Adaptable & Livable Apartments

| CURRENT REVISION COMMENTS | | |
|--|-------------------------|----------|
| 5 | Development Application | 13.07.18 |

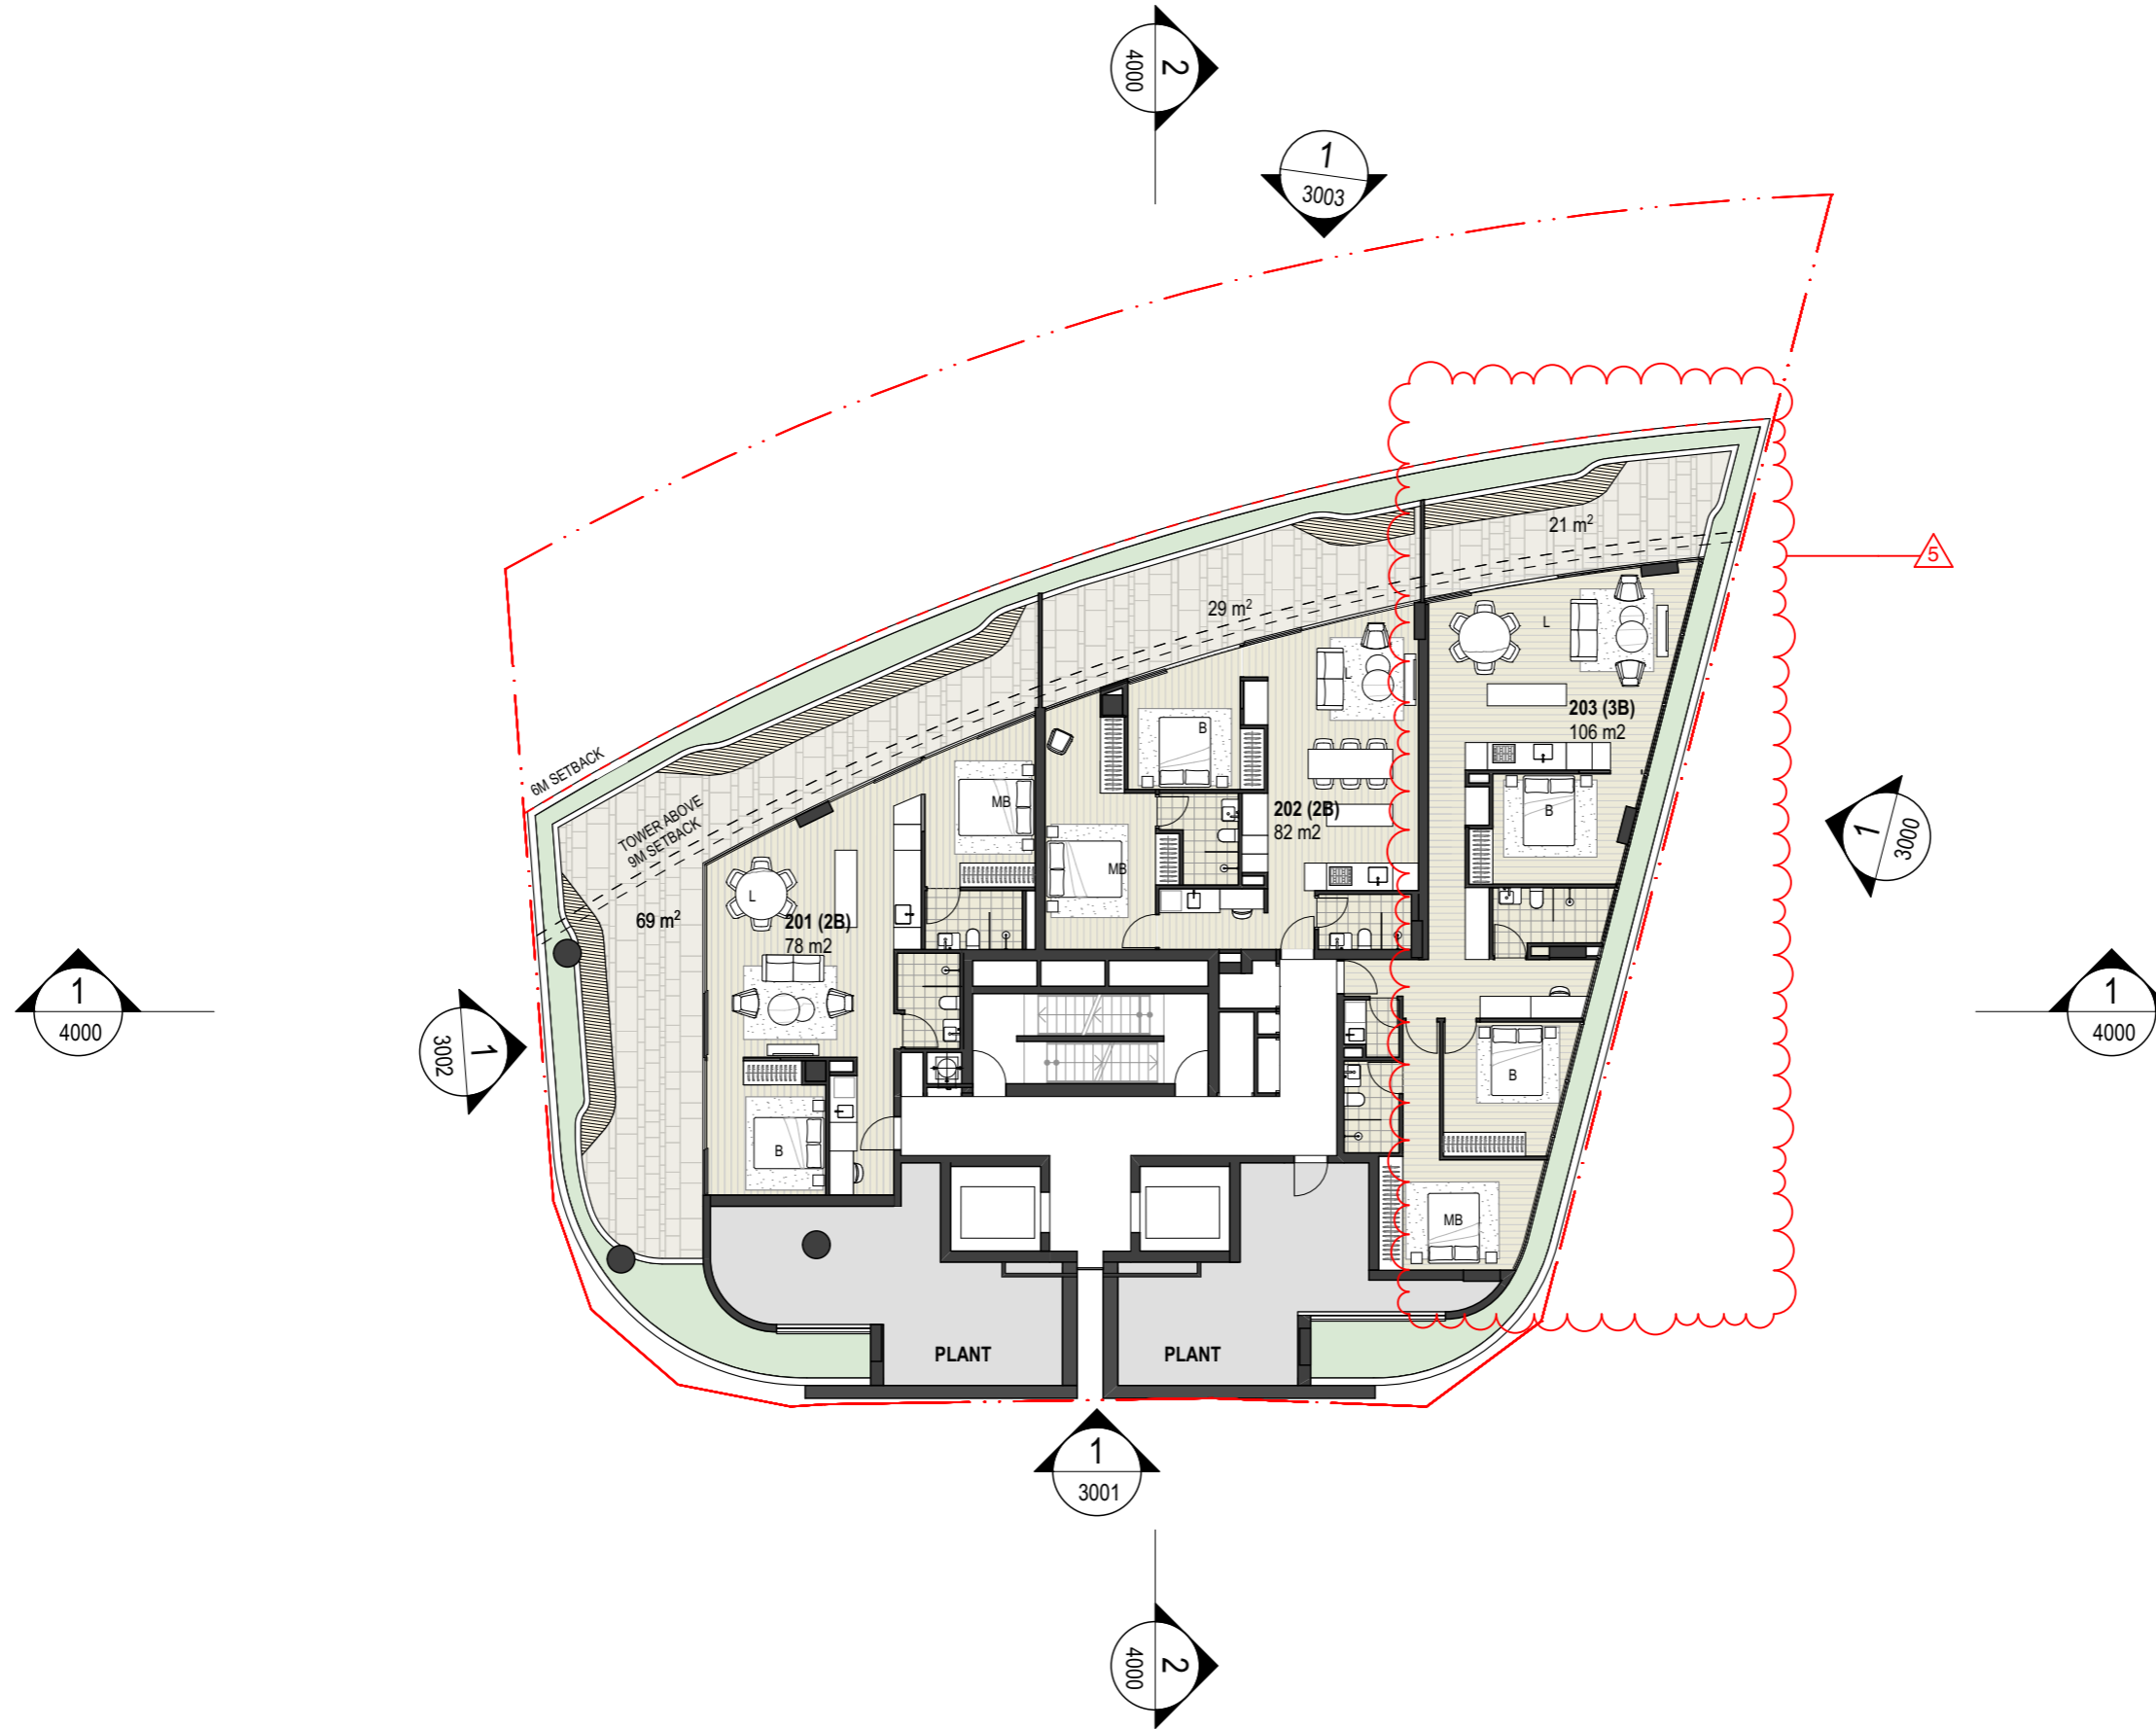
| CURRENT REVISION COMMENTS | | |
|--|-------------------------|----------|
| 1. 9M SETBACK FROM WESTERN BOUNDARY FOR OVERLAND FLOW PATH. | | |
| 2. REVIEWED DRIVEWAY AND GROUND FLOOR RLs TO ACCOMMODATE RUBBISH COLLECTION REQUIREMENTS | | |
| 3. TURNTABLE ADDED FOR SRV TURNING | | |
| 4. RL GROUND FLOOR CHANGED TO RL8.25. | | |
| 5. NORTH PATH ACCESS MODIFIED. | | |
| 6. ACCESSIBLE LIFT ADDED TO EAST ENTRY. | | |
| 7. SUBSTATION, FIRE CONTROL ROOM AND BOOSTER VALVE RELOCATED. | | |
| 8. WATER METER AND GAS REGULATOR RELOCATED. | | |
| 9. BIKE PARKING RELOCATED. | | |
| 10. SERVICES WEST OF CAR LIFT MODIFIED. | | |
| 11. NOTES ADDED FOR FLOOD PROTECTION. | | |
| 12. GLAZED FACADE FROM EAST LOBBY TO LANDSCAPED ZONE. | | |
| 13. RELOCATED MAILBOXES | | |
| 14. NEW STAIRS TO WEST LOBBY ACCESS | | |

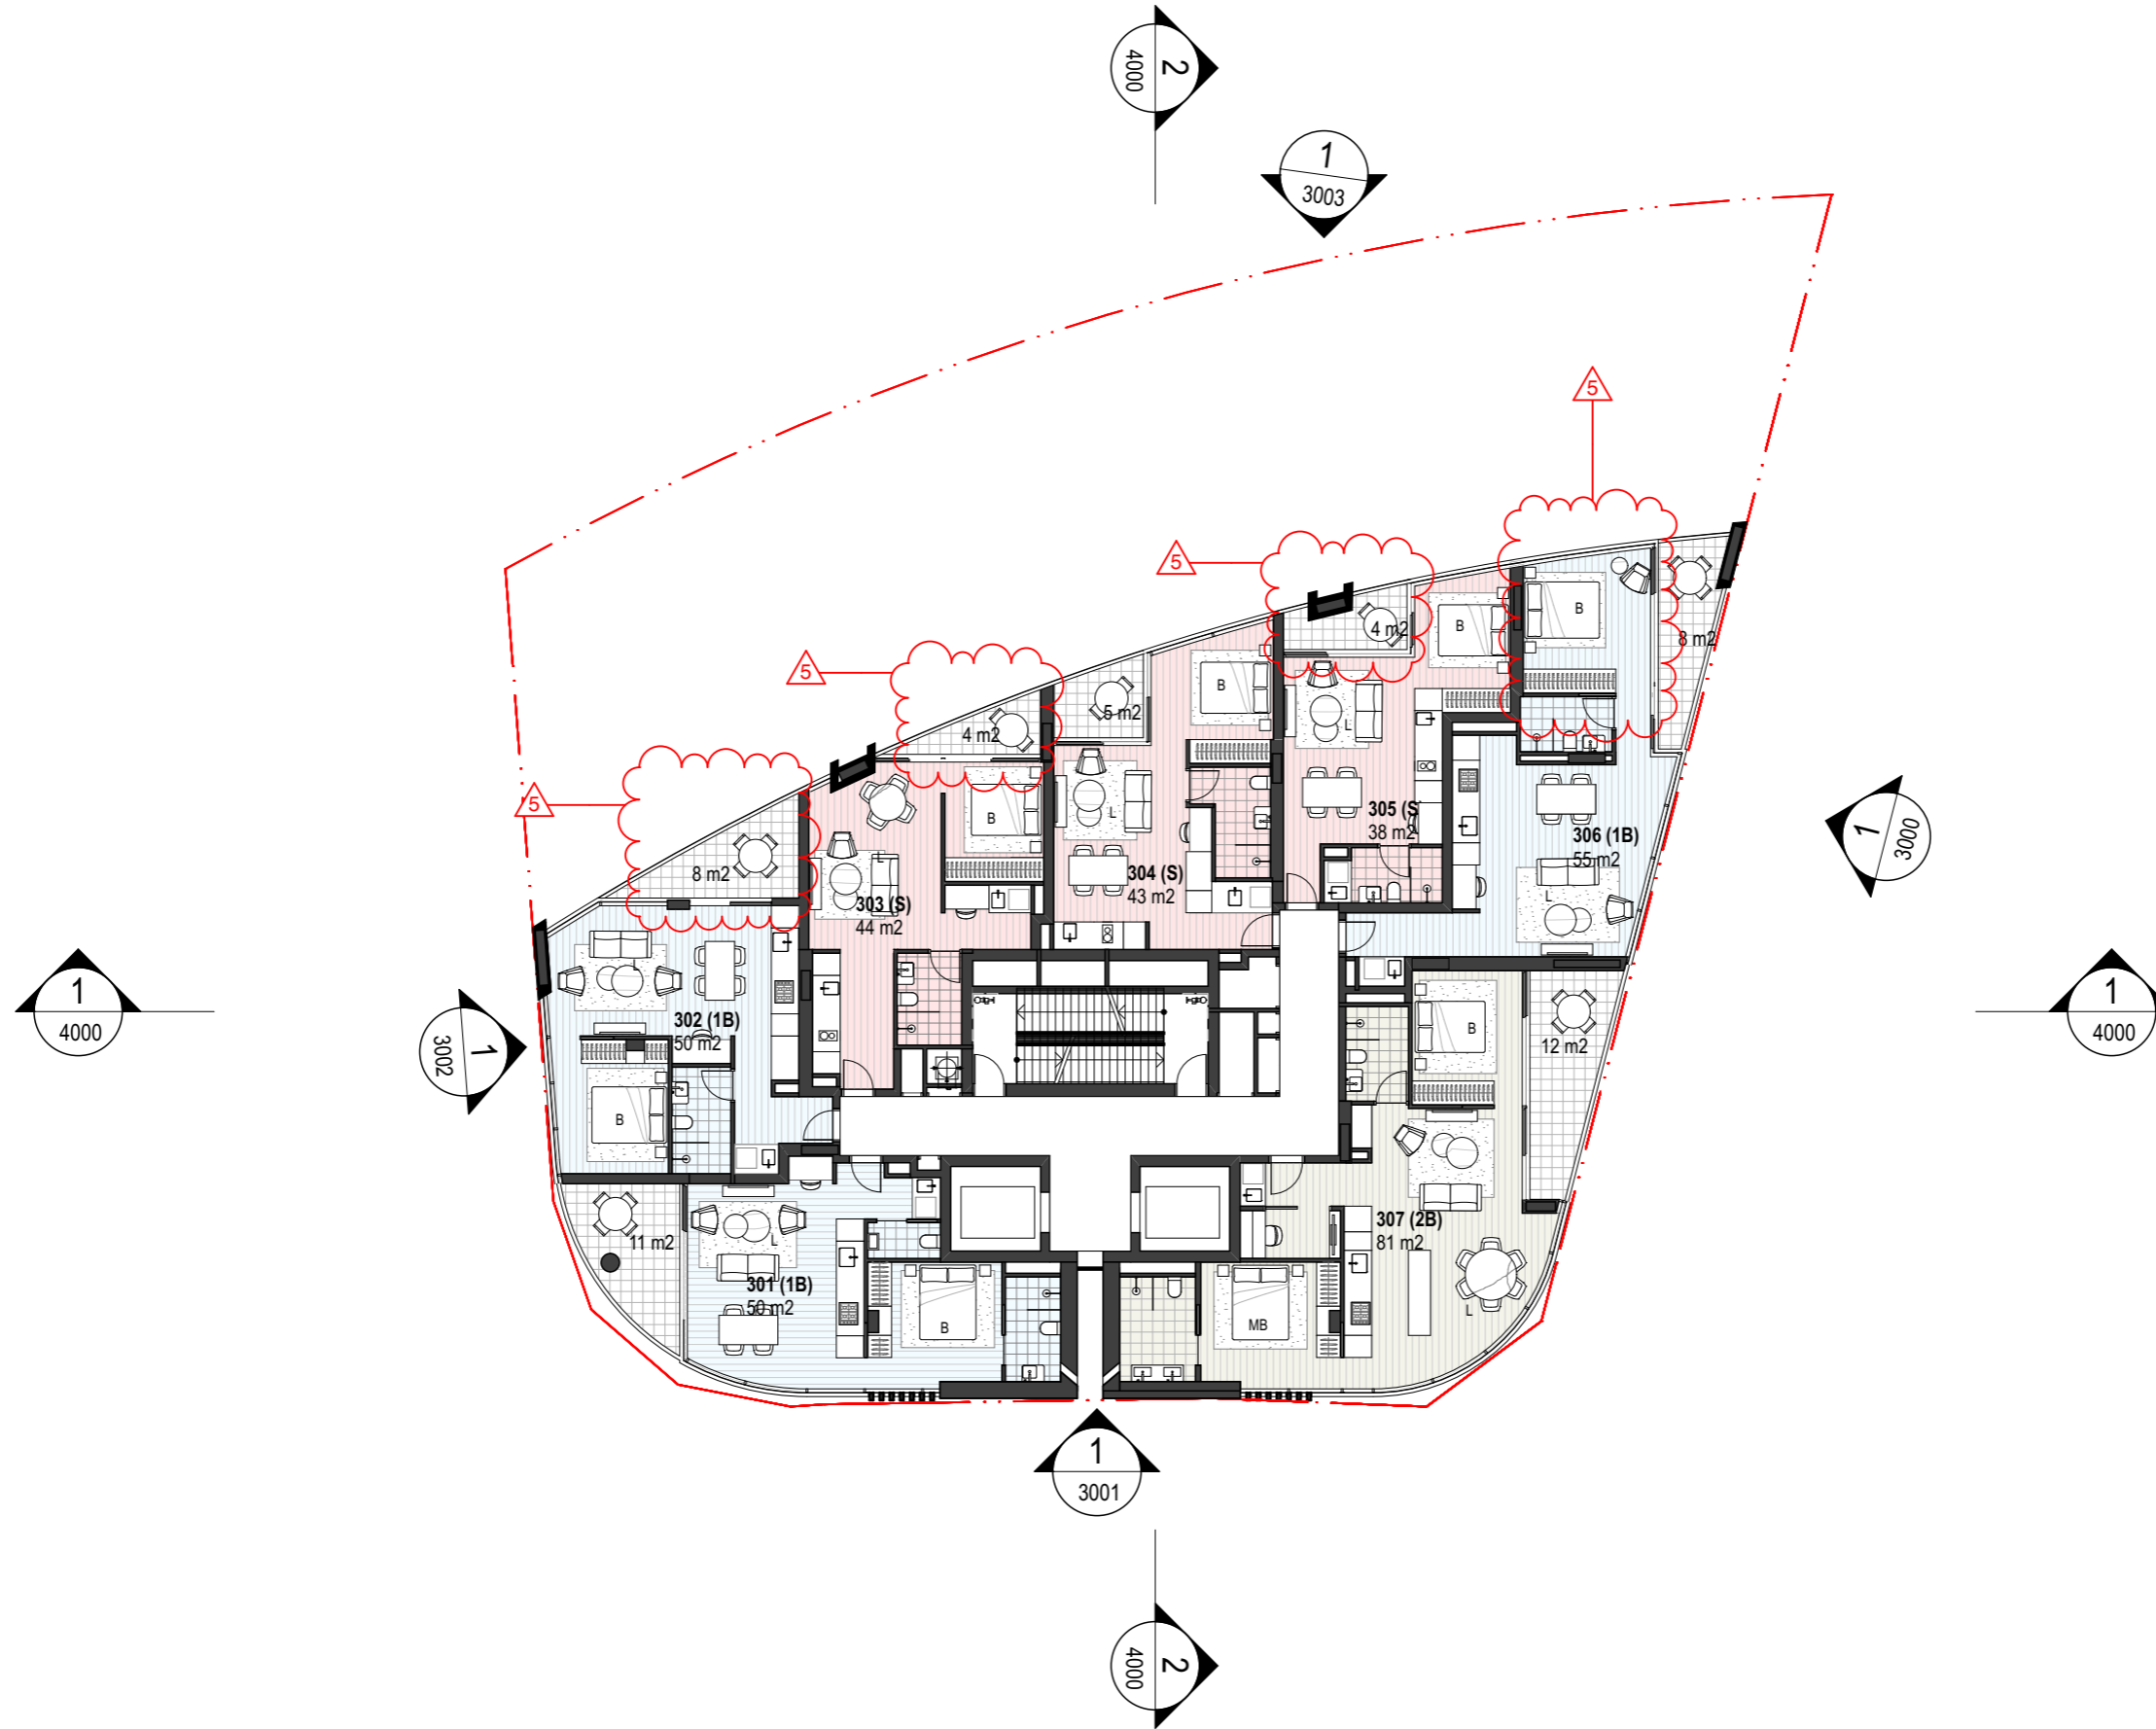
| CURRENT REVISION COMMENTS | | |
|---|-------------------------|----------|
| 1. LEVEL 2 INTERNAL LAYOUT CHANGED. UNIT 203 CHANGED TO 3-BEDROOM. UNITS 201 AND 202 HAVEN'T CHANGED. | | |

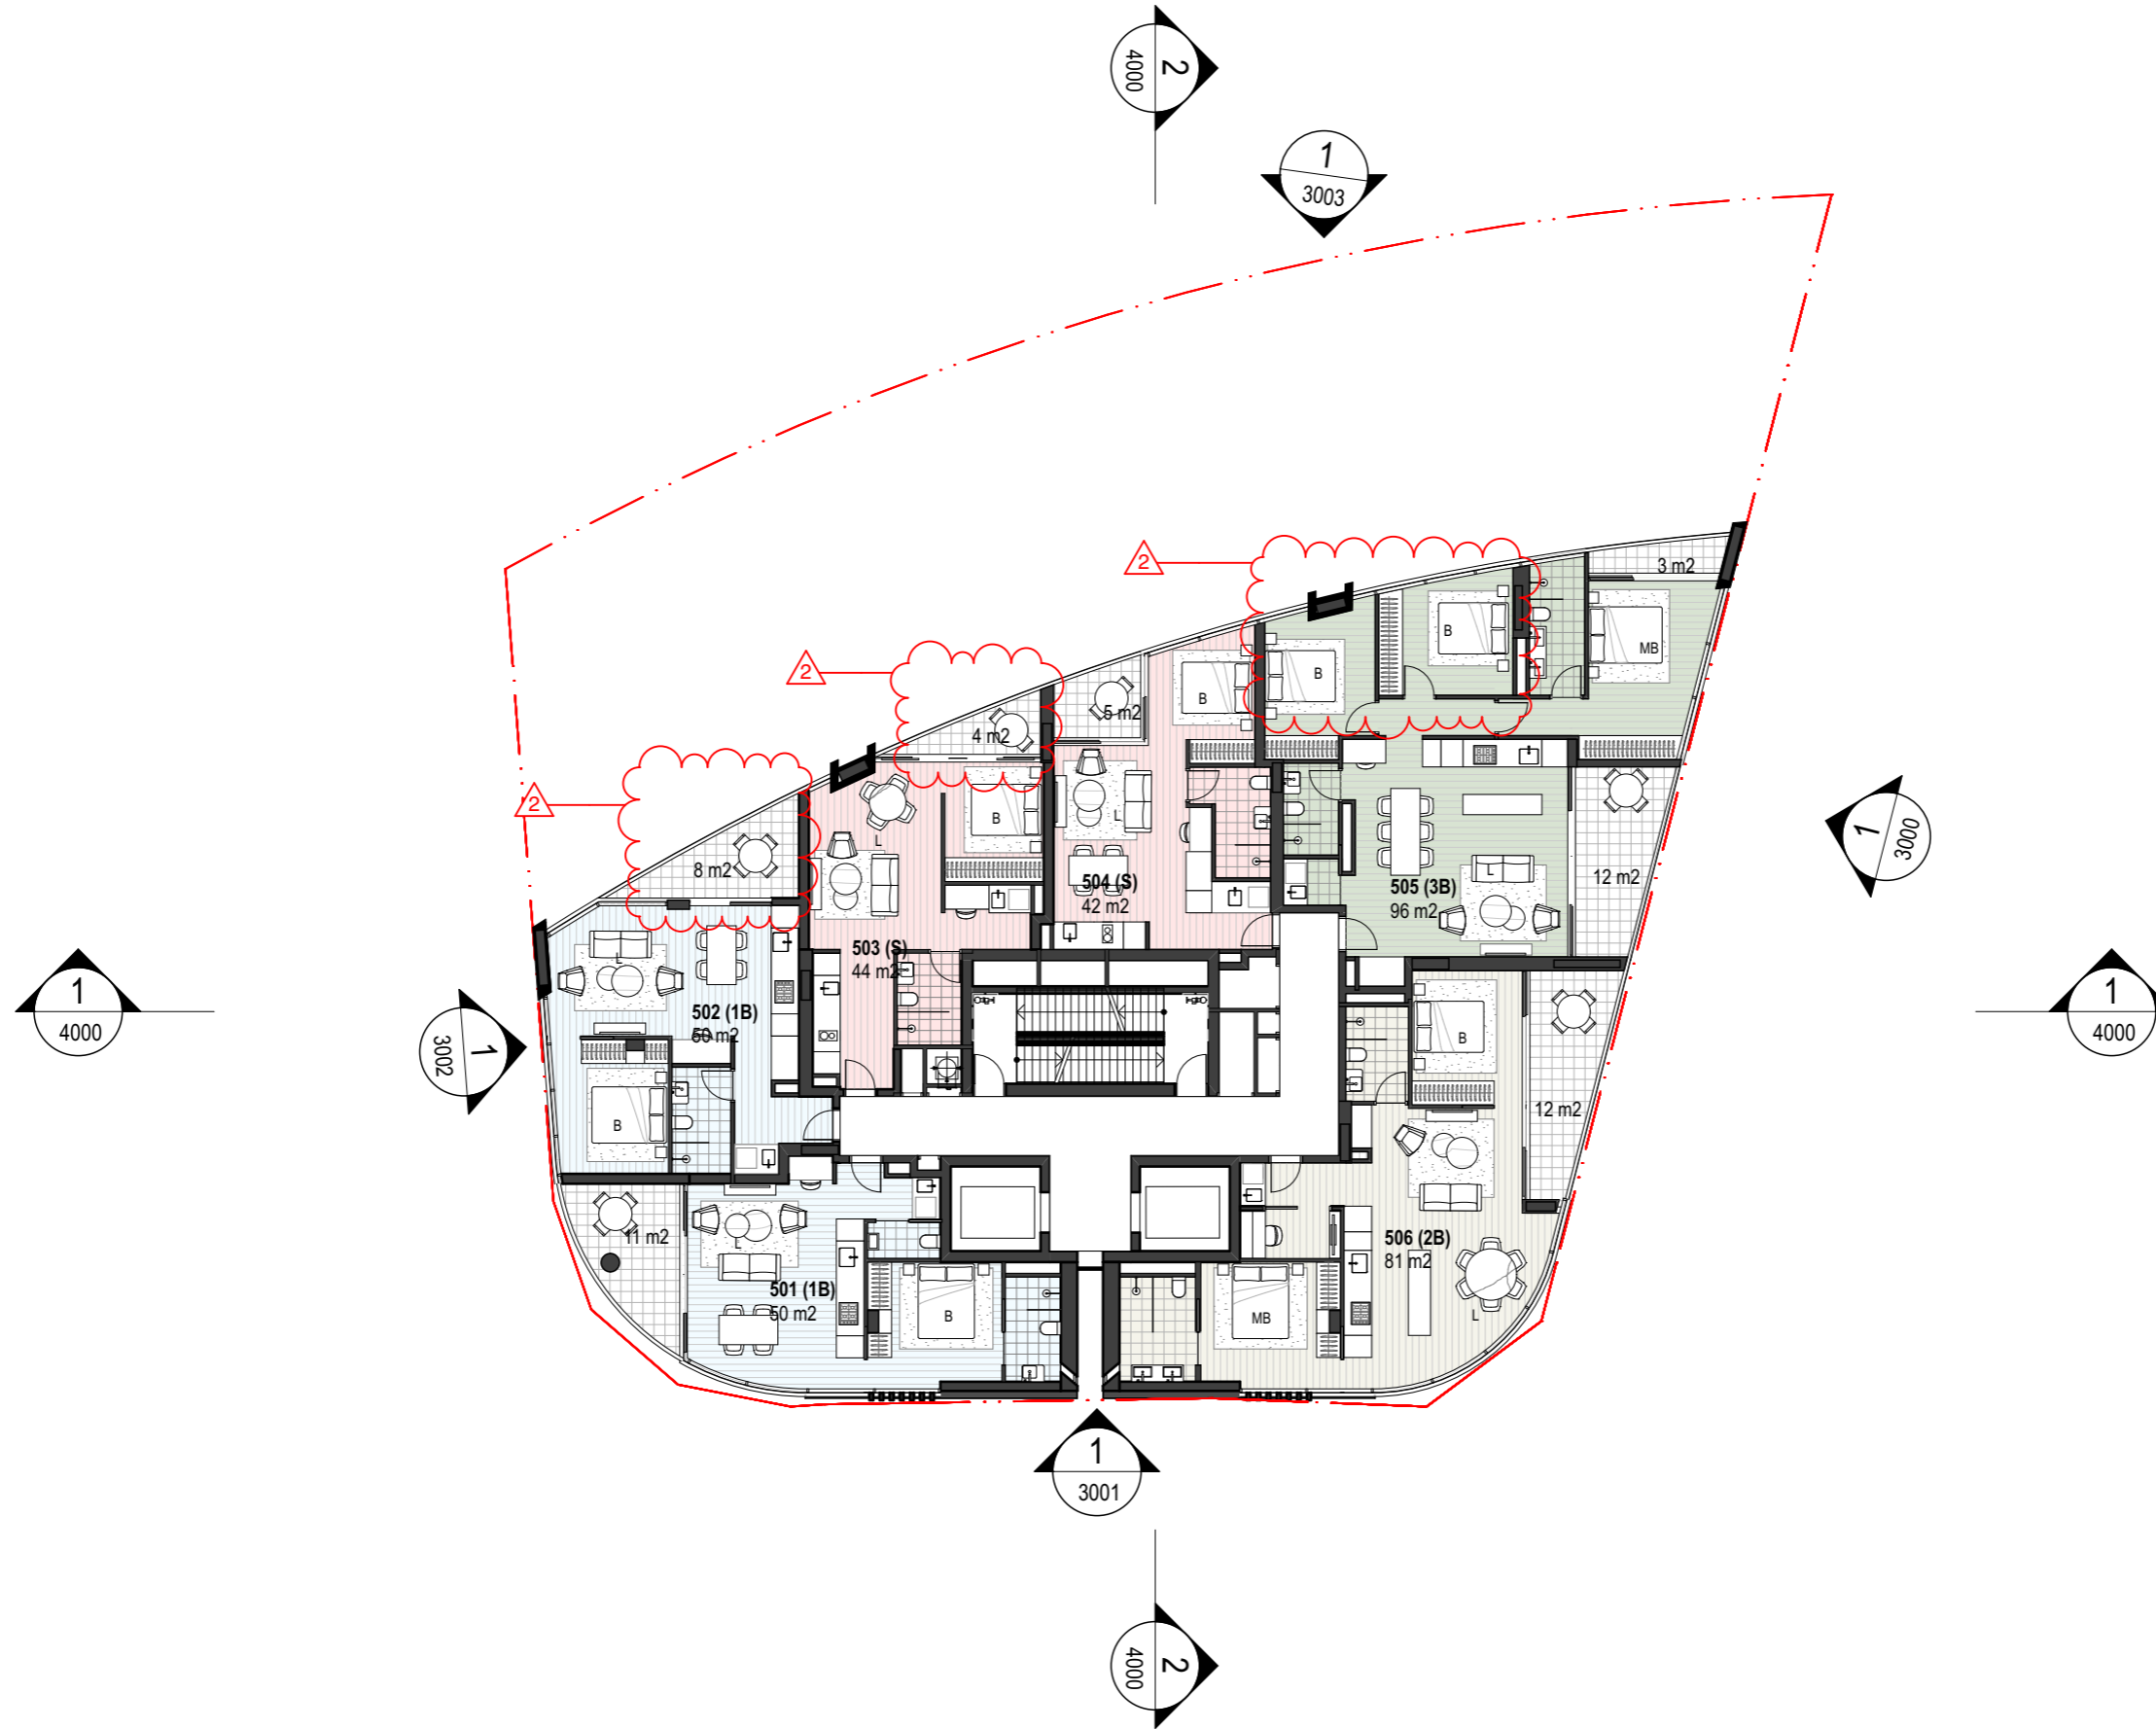
| CURRENT REVISION COMMENTS | | |
|---|-------------------------|----------|
| 1. UNIT 306 MODIFIED TO ACCOMODATE 3x3m IN BEDROOM. | | |
| 2. BALCONIES UNITS 302, 303 AND 305 MODIFIED TO ACHIEVE 1m DEPTH FOR BALCONY COUNTED AREA | | |
